SERVICE BULLETIN REVISION NOTICE

POWER PLANT — INTRODUCTION OF A LEASE COMPANY TITLE PLATE

Turbojet Engine Service Bulletin No. V2500-ENG-71-0326 Revision No. 1 dated November 8, 2019.

Reason for the Revision

INSTALLATION OF THE LEASE COMPANY TITLE PLATE FIGURE 1 (SHEET 2 OF 2)

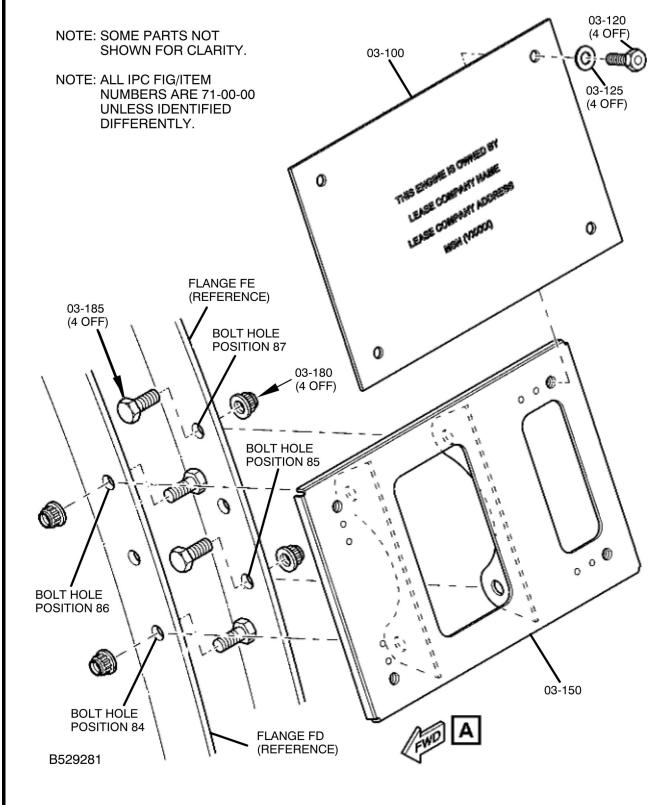
The purpose of this revision is to correct figure item numbers in Figure 1 (Sheet 2 of 2), and associated steps in the Accomplishment Instructions.

- Install the lease company title plate on the placard holder (Refer to Figure 1).
 - (1) Hold the placard (71-00-00, 03-100) in the correct position on the placard holder (71-00-00, 03-150).

- (2) Install the four (4) screws (71-00-00, 03-120) with the four washers (71-00-00, 03-125), fingertight.
 - (3) Torque the four (4) screws (71-00-00, 03-120) to 40 lbf in. (4.5 N.m).
